ADDENDUM NO. 03

**Westfield Washington School Corporation
Westfield Middle School West (Site Package)
17707 Centennial Road,
Westfield, IN. 46074**

PROJECT: Westfield Middle School – West (Site Package)

DATE: June 24, 2024

DRAWING NUMBER
C253

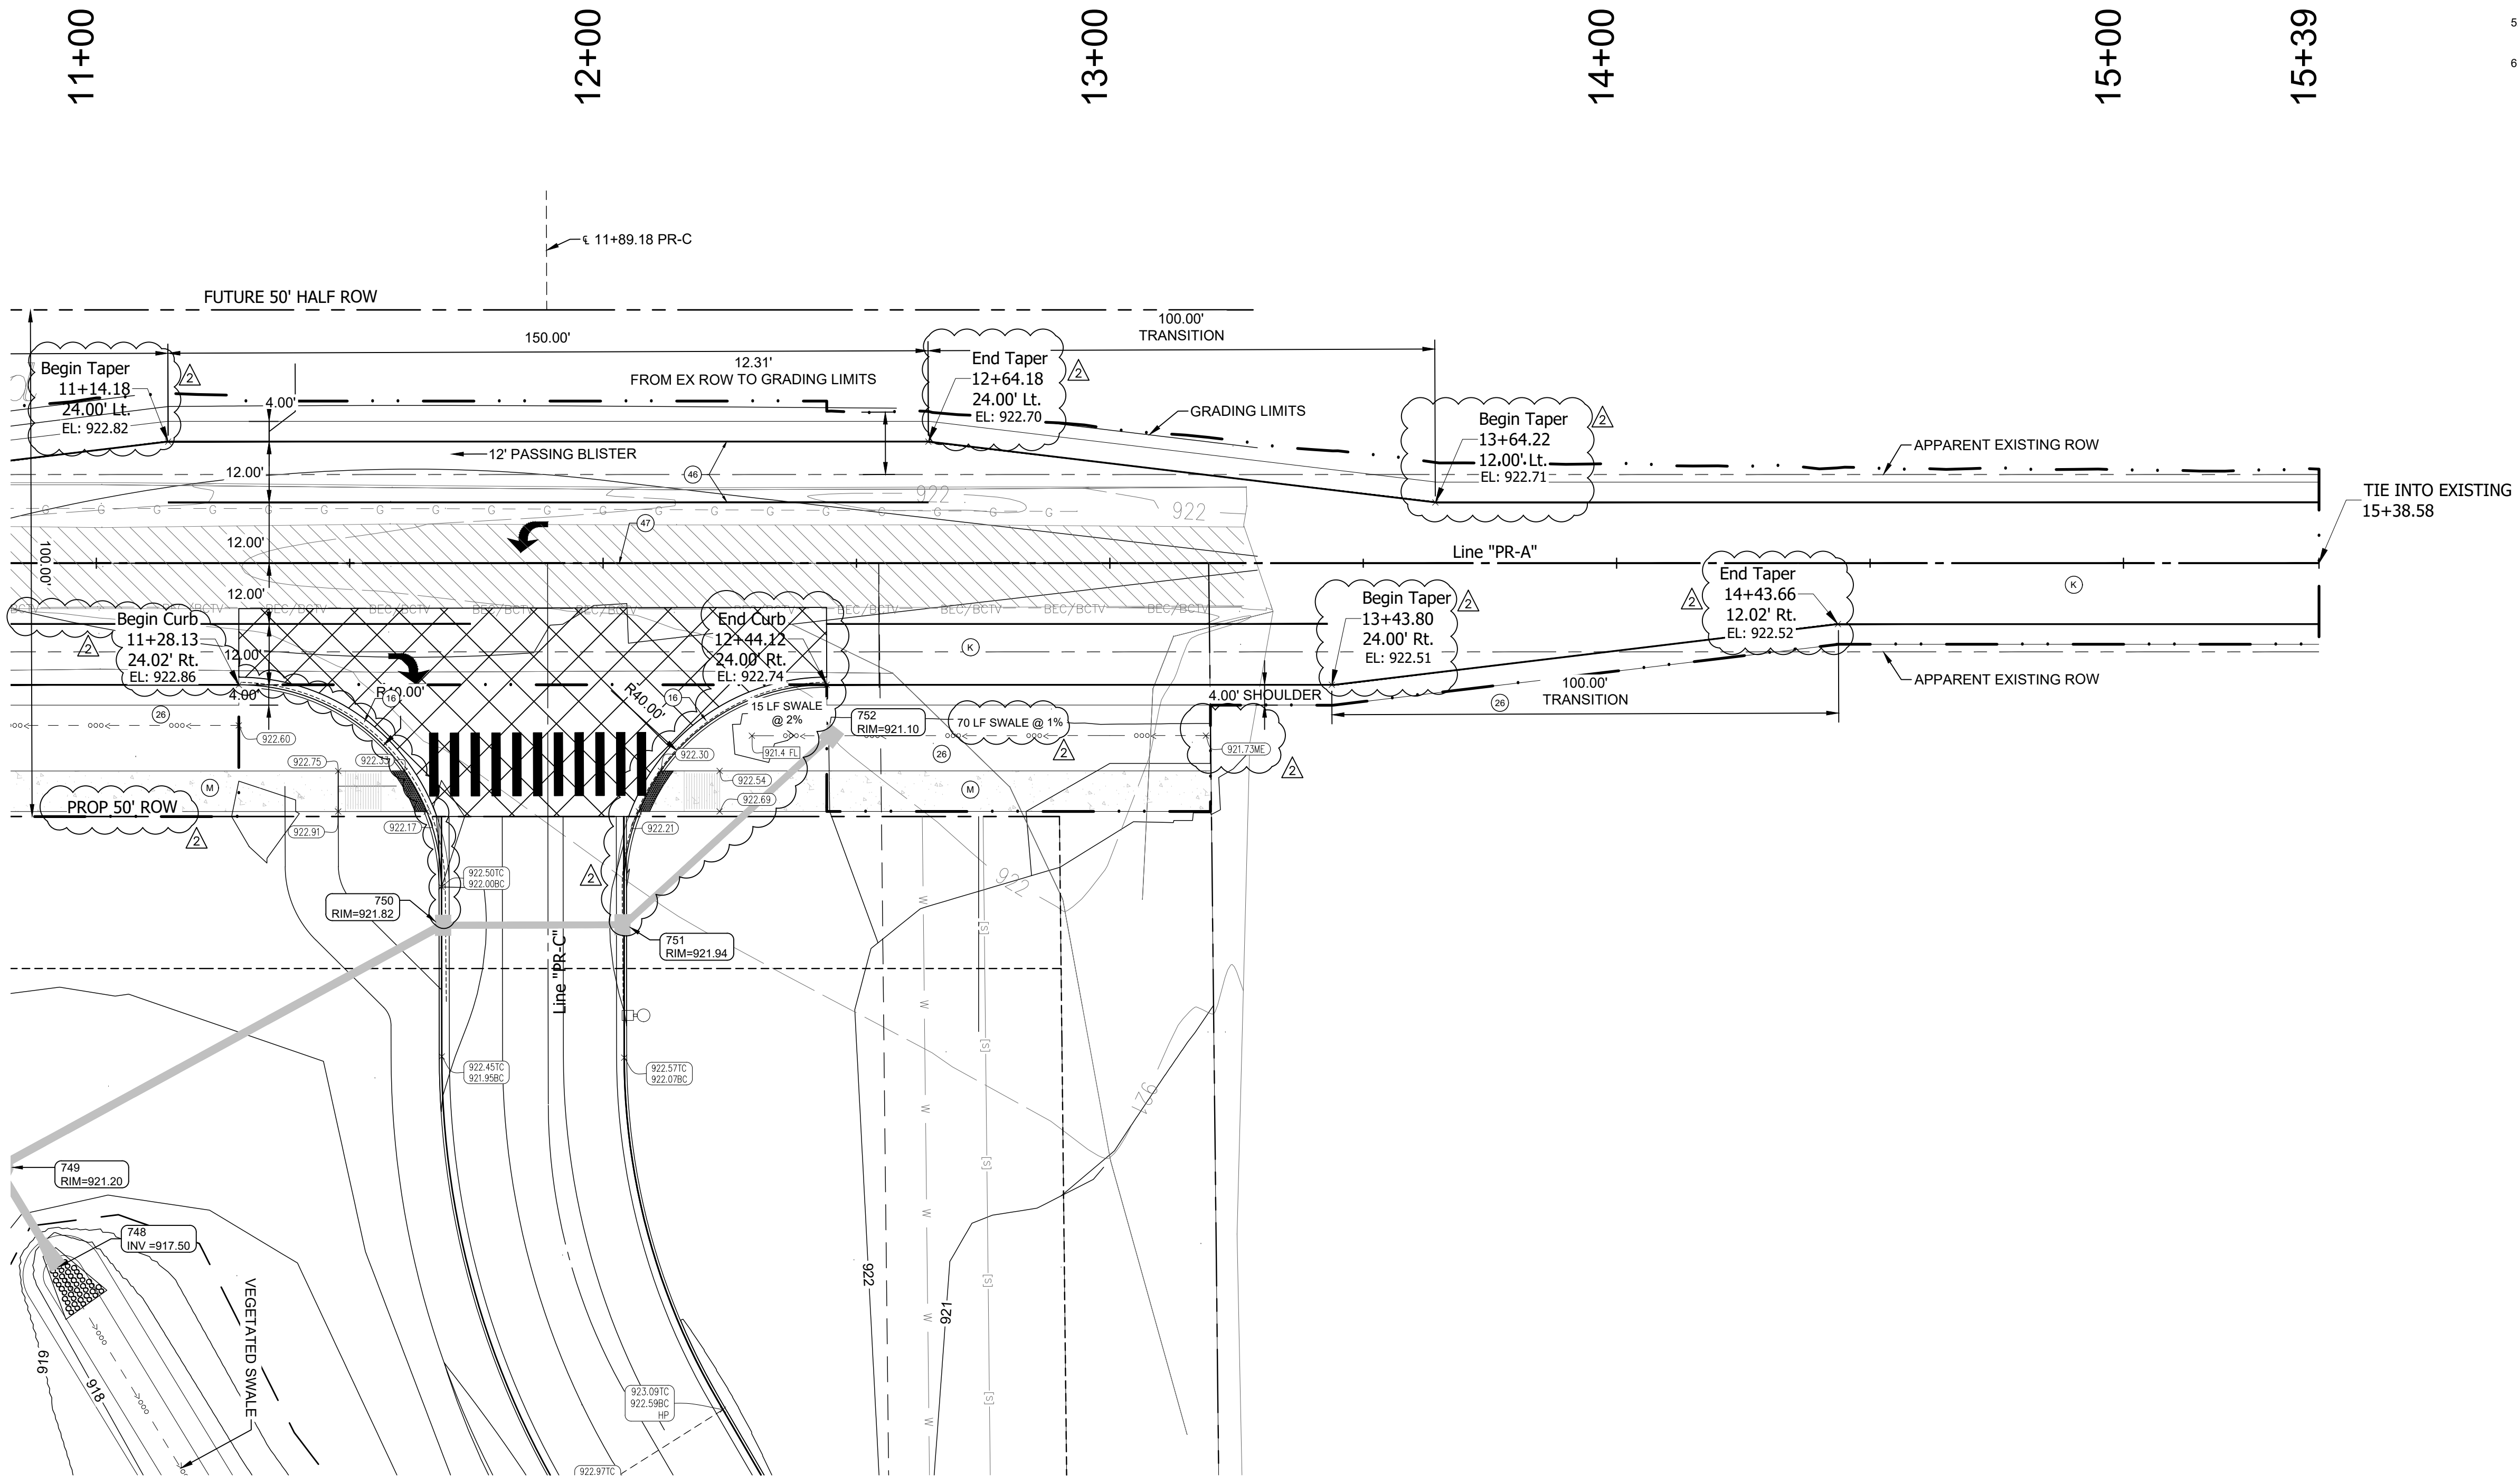
3.4 C253 PLAN PR-A STA 05+00 TO STA 11+00

- A. Fixed SSD to go around radius
- B. Fix grading
- C. Added Elevations to the taper labels
- D. Adjusted Swale Labels
- E. New Rim Elevation for Str. 749

DRAWING NUMBER
C255

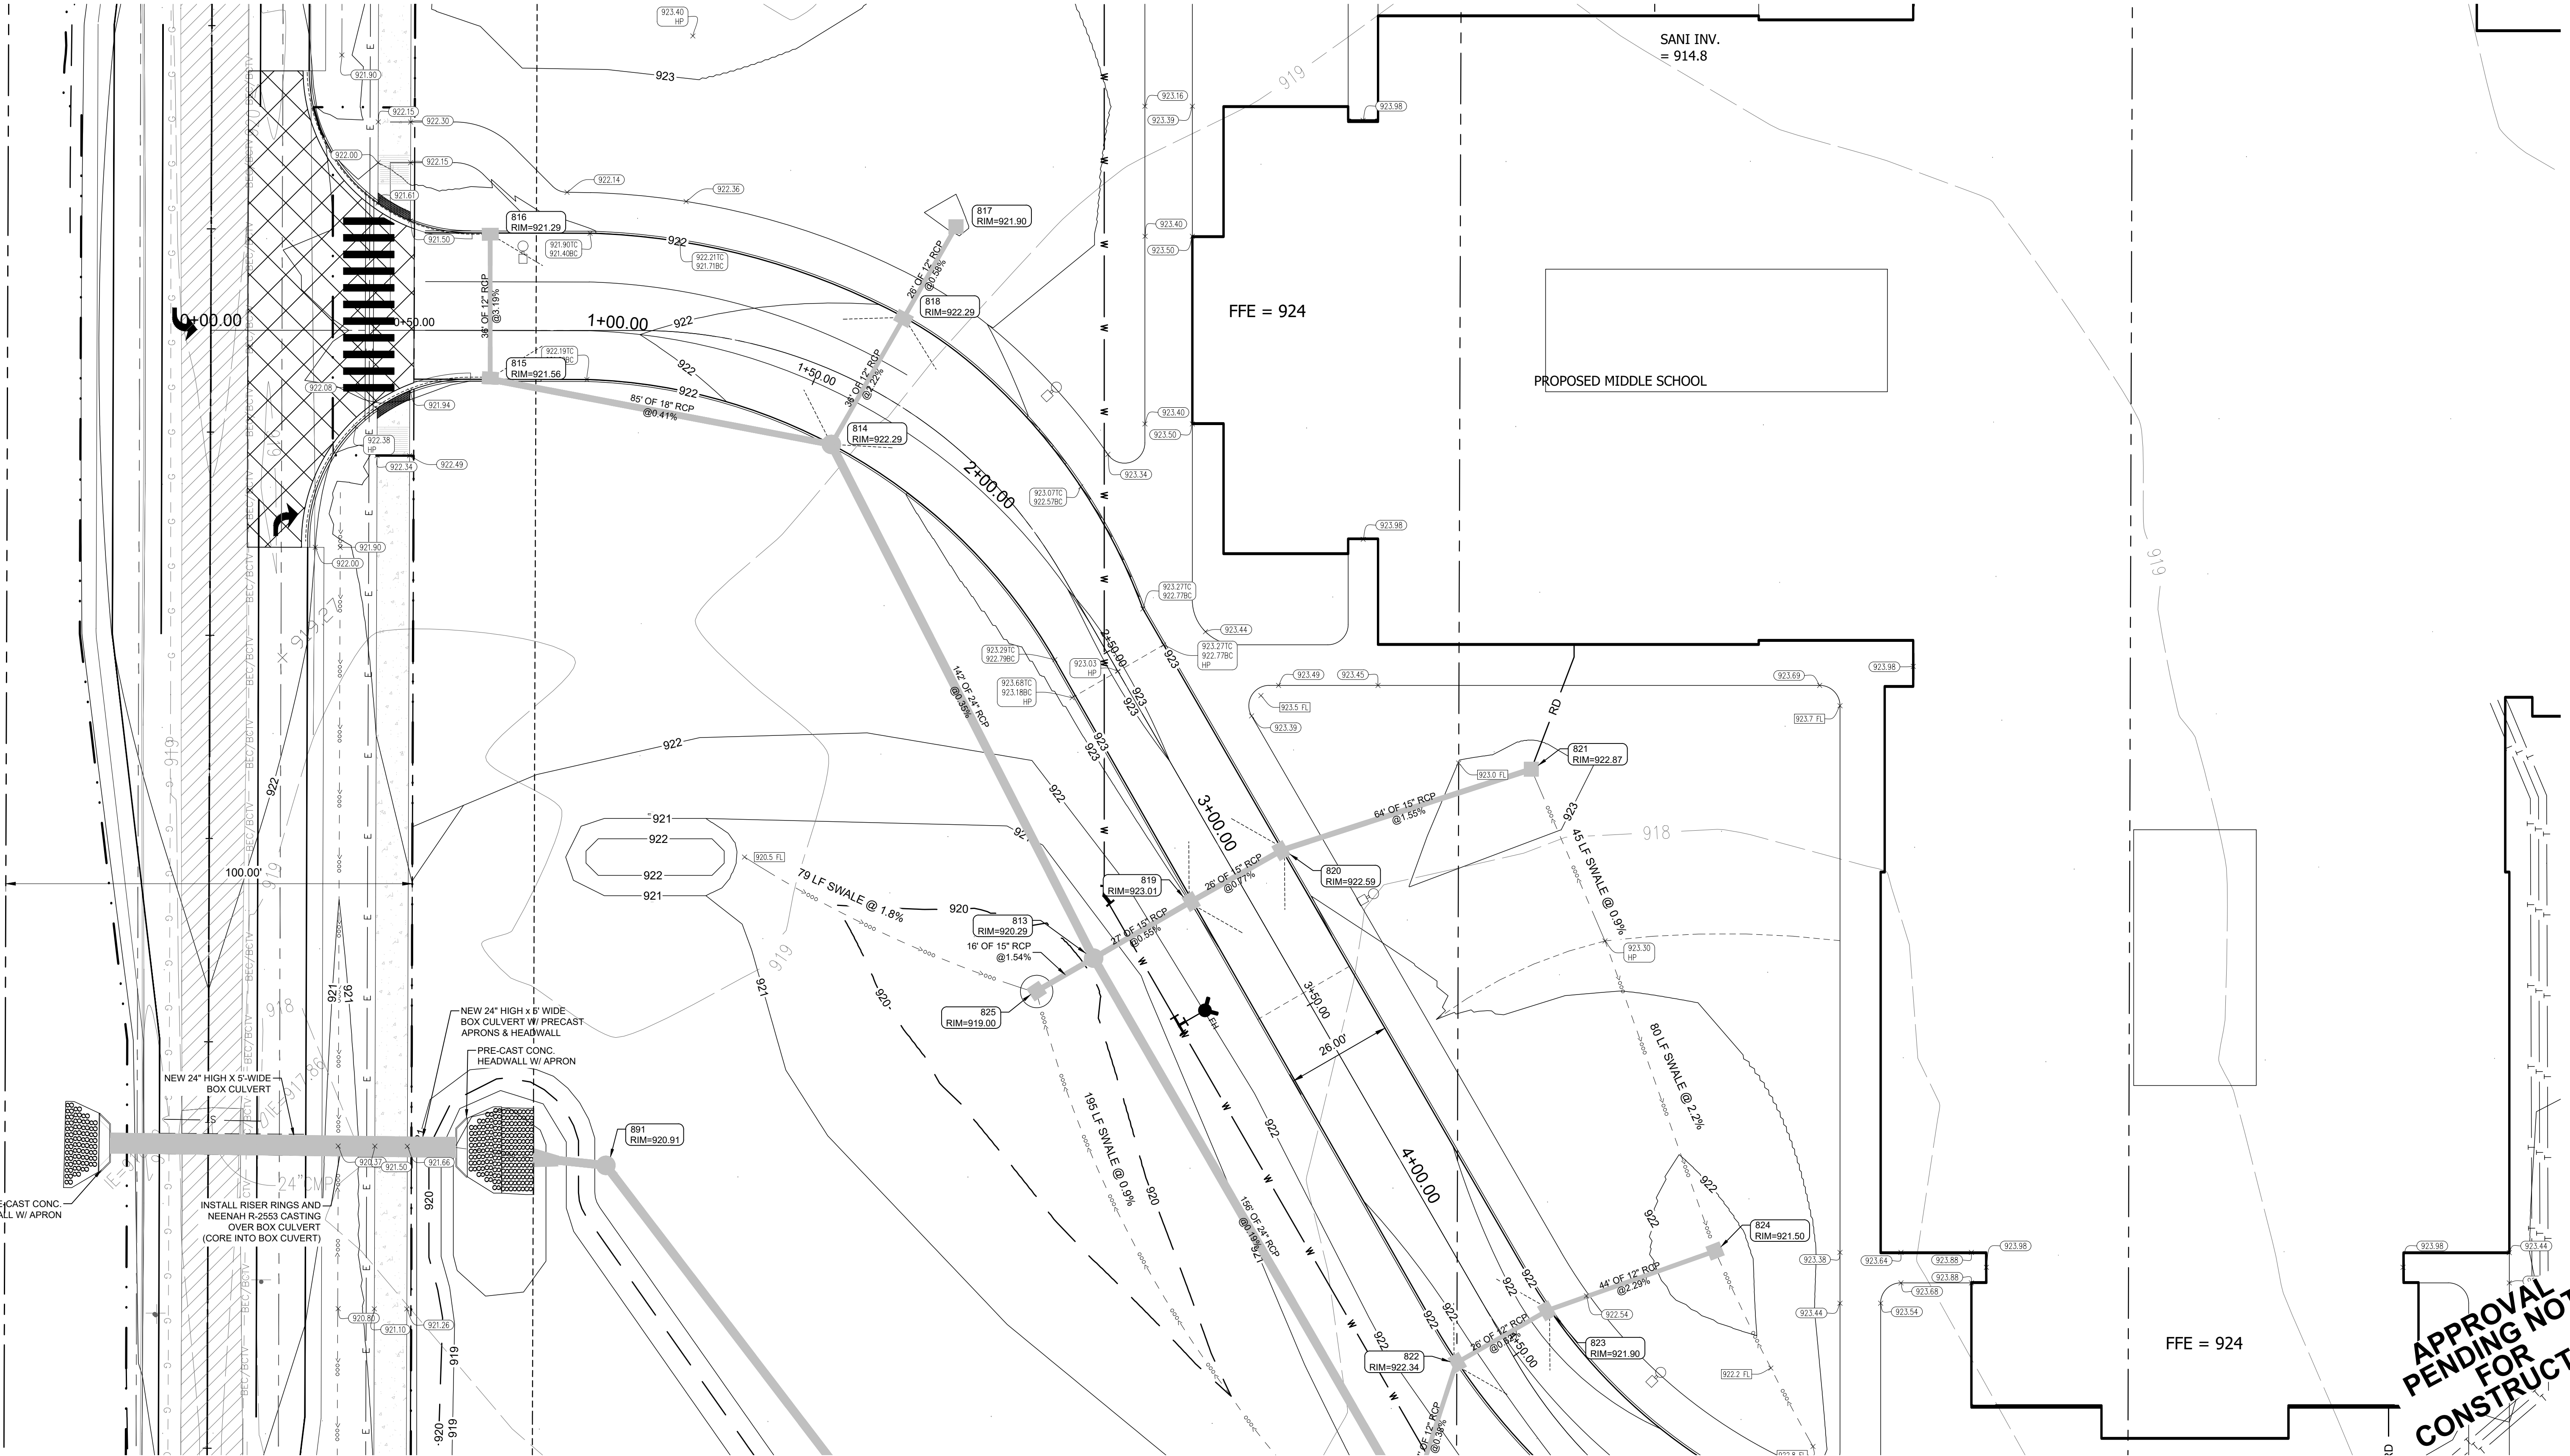
3.5 C255 PLAN PR-A STA 11+00 TO STA 15+39

- A. Added Proposed 50' ROW label
- B. Added Elevations to the taper labels
- C. Fixed grading

DRAWING TITLE:
PLAN
"PR-C"
STA. 12+00
TO
STA. 17+00

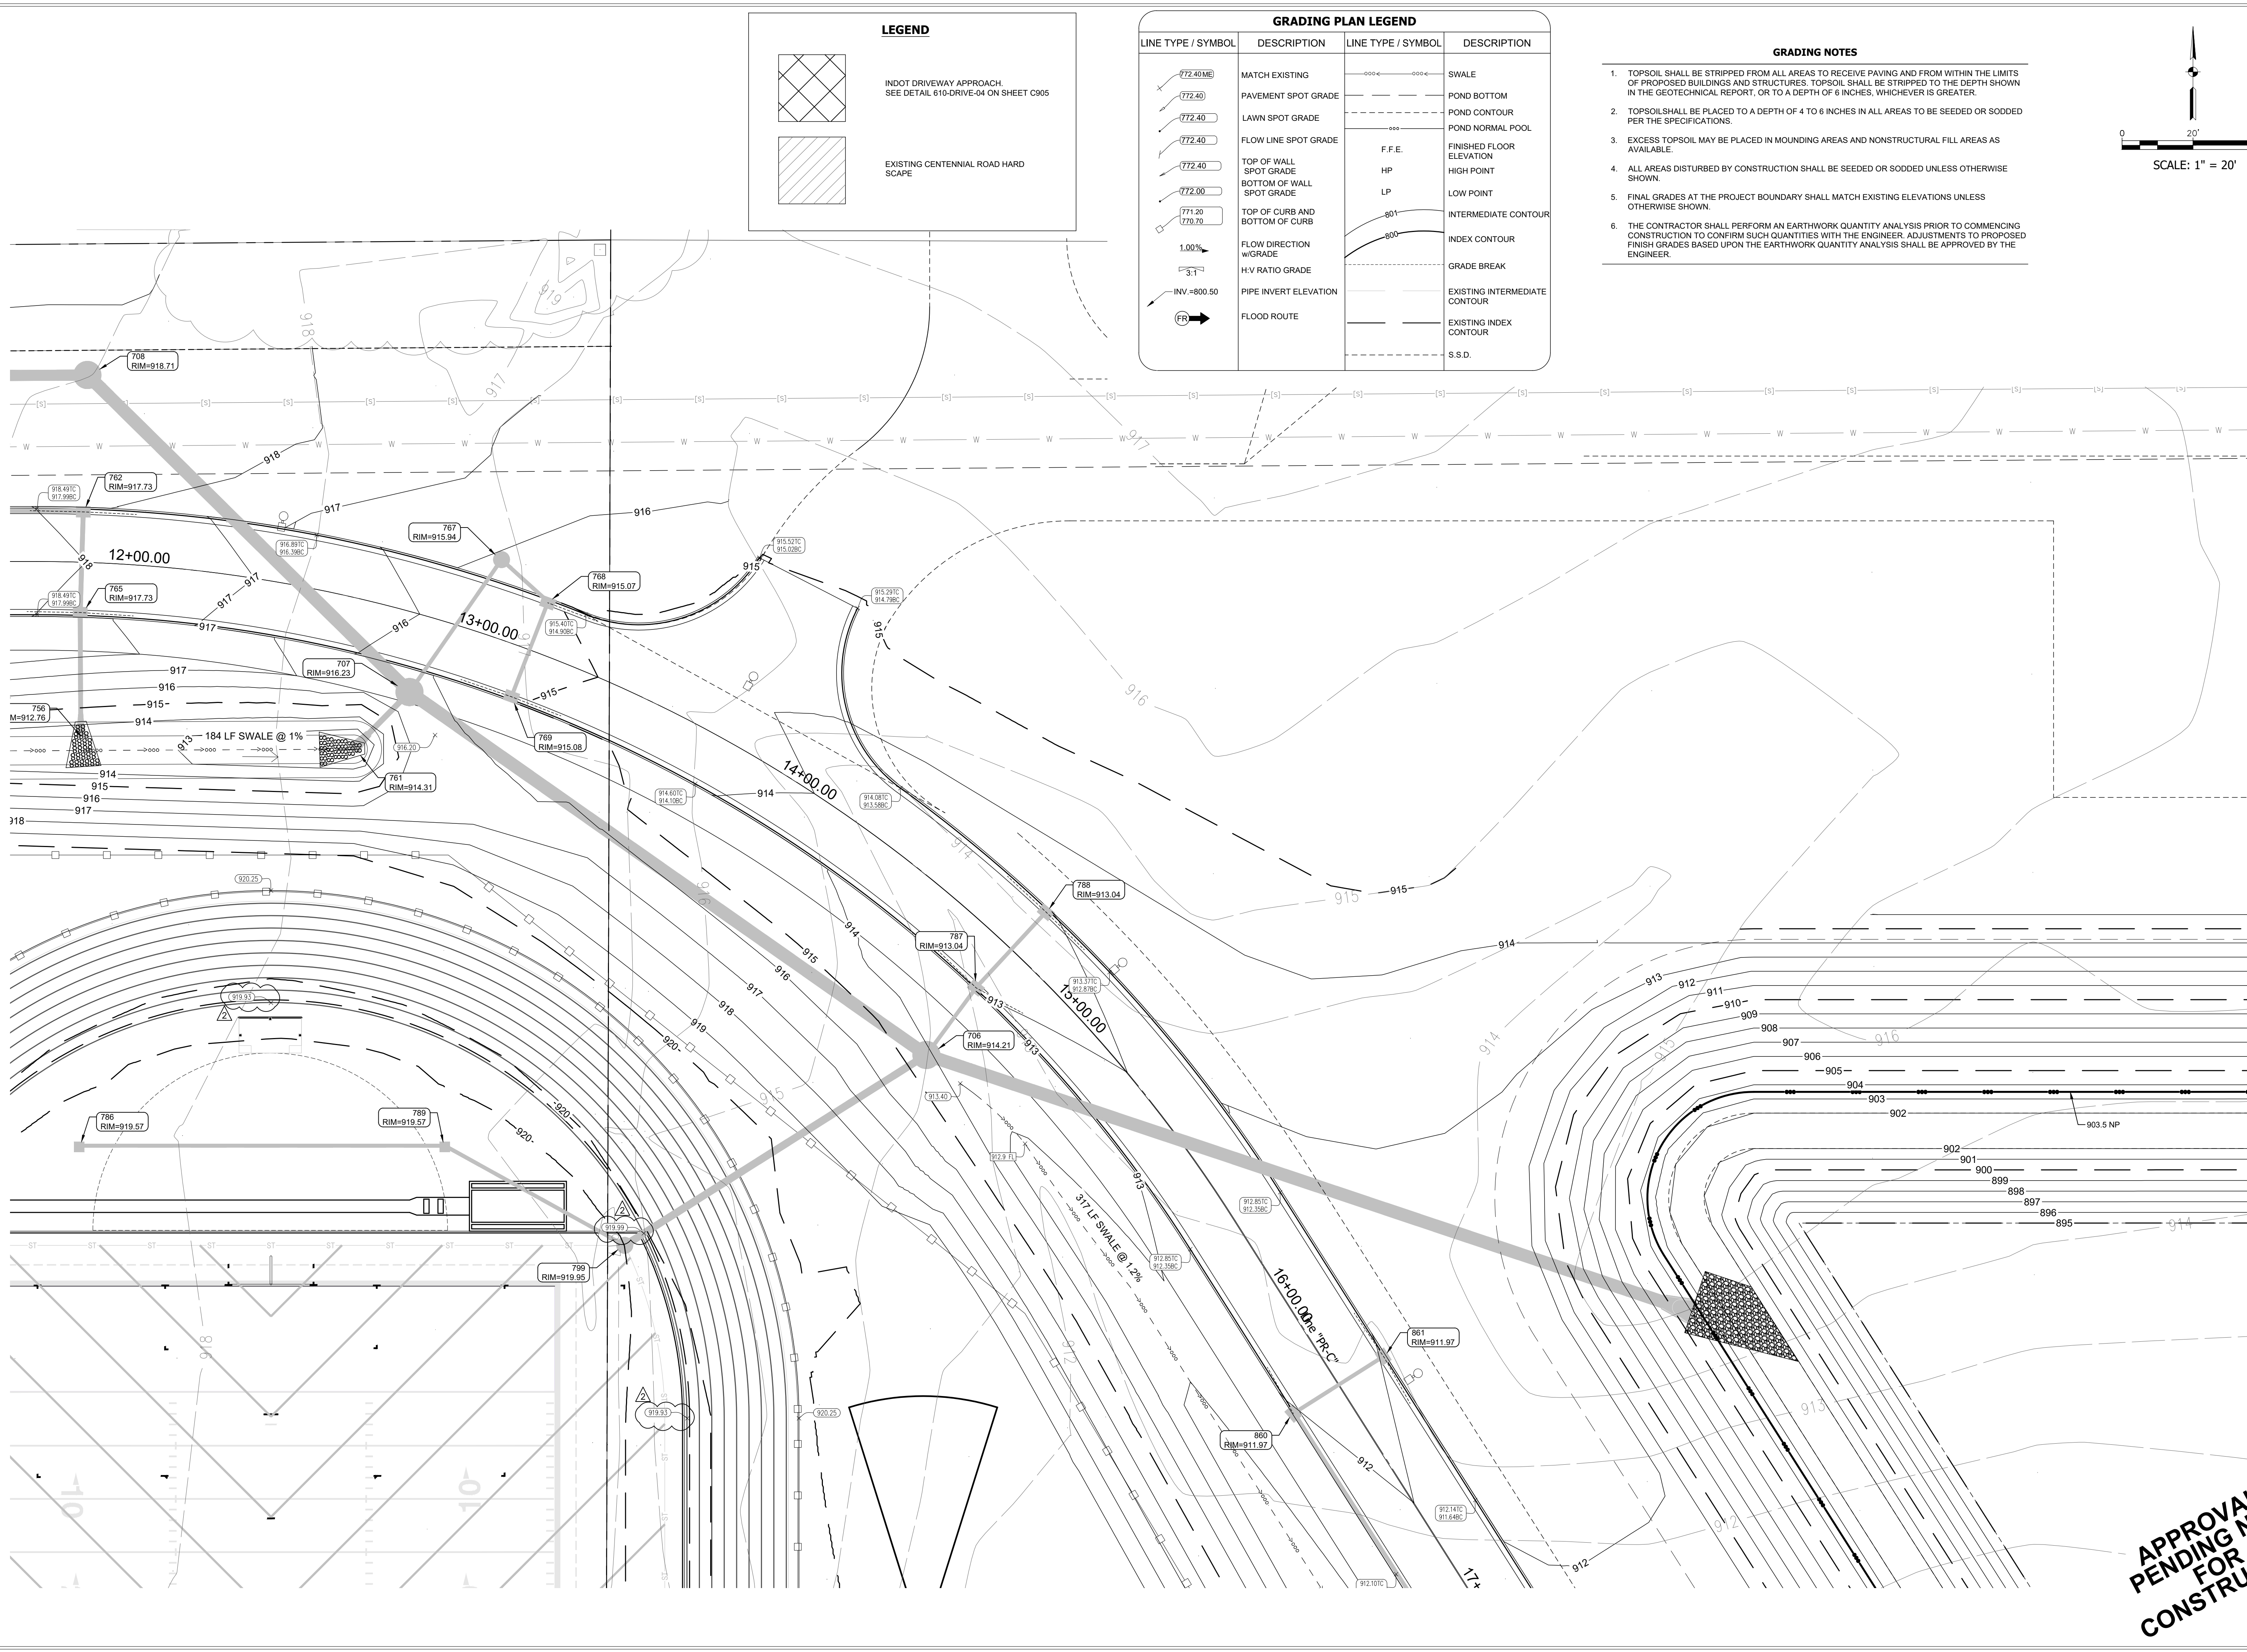
3.9 C265 PLAN PR-C STA 12+00 TO STA 17+00

- A. Added Spot Grades between track and football field
